**13757T326-SRL-CO-YQ-01-S2-PI**

**Application: SCC/0045/23SE – Air Quality Response.**

**Proposal: Construction and operation of an anaerobic digestion facility, associated infrastructure and new access road, connecting pipeline and covered digestate lagoons.**

**Location: Land to the north of Spring Grove Farm, Withersfield, Suffolk, CB9 7SW**

Below are the site images labelling both sites and their respective local sensitive receptors.

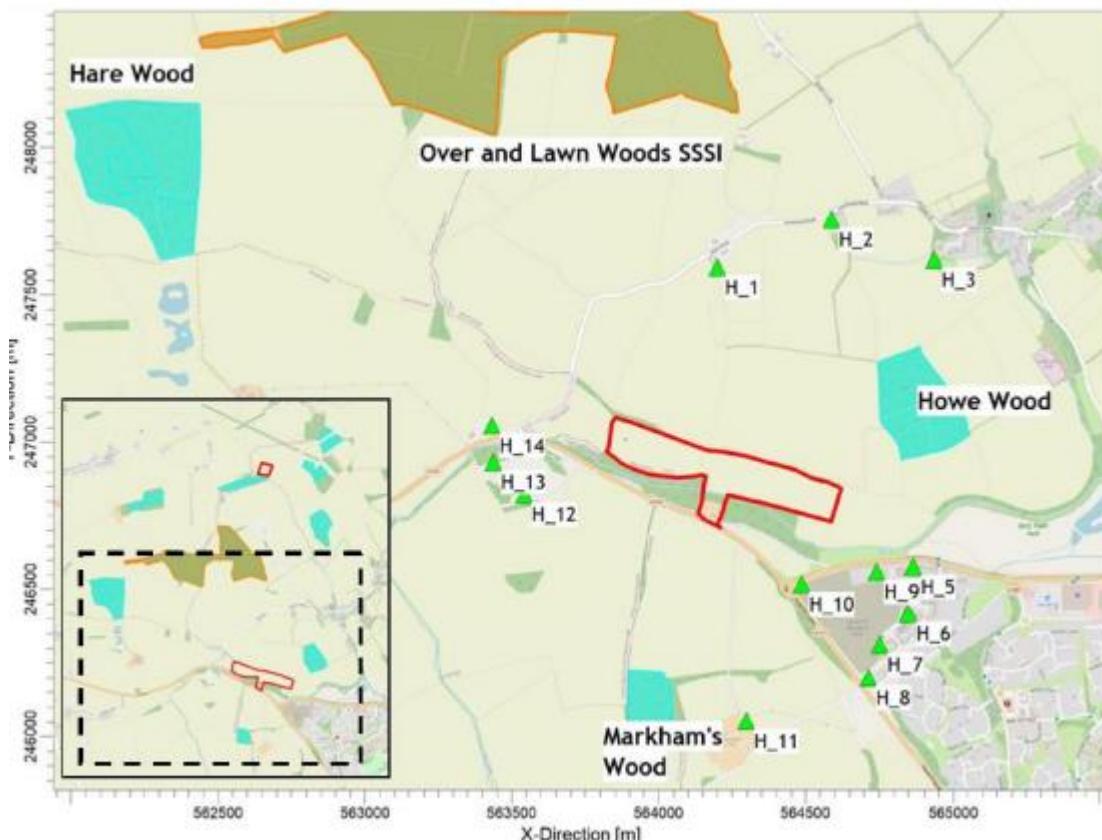
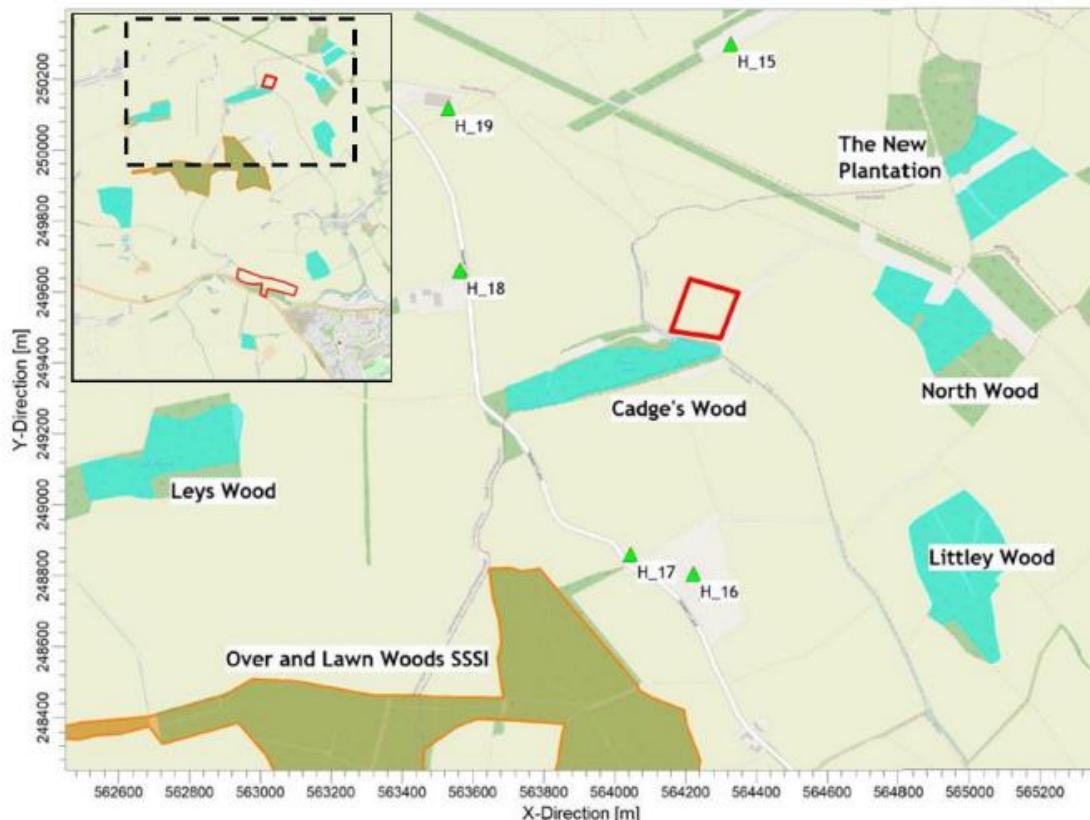
The ES identifies the closest human receptors as being 'Three Counties Way', 320m southeast, and 'Off A1307', 320m southwest. These receptors have high sensitivity to air quality effects. The closest commercial receptors including 'The Epicentre Haverhill', 210m southeast, have medium sensitivity to air quality effects.

The ES identifies the closest ecological receptors as being the Ancient Woodland of 'Cadge's Wood', 20m southwest, and 'Howe Wood', 240m northeast. The ES identifies 9 ecological receptors including ancient woodland and a site of special scientific interest (SSSI) within 2km of the sites.
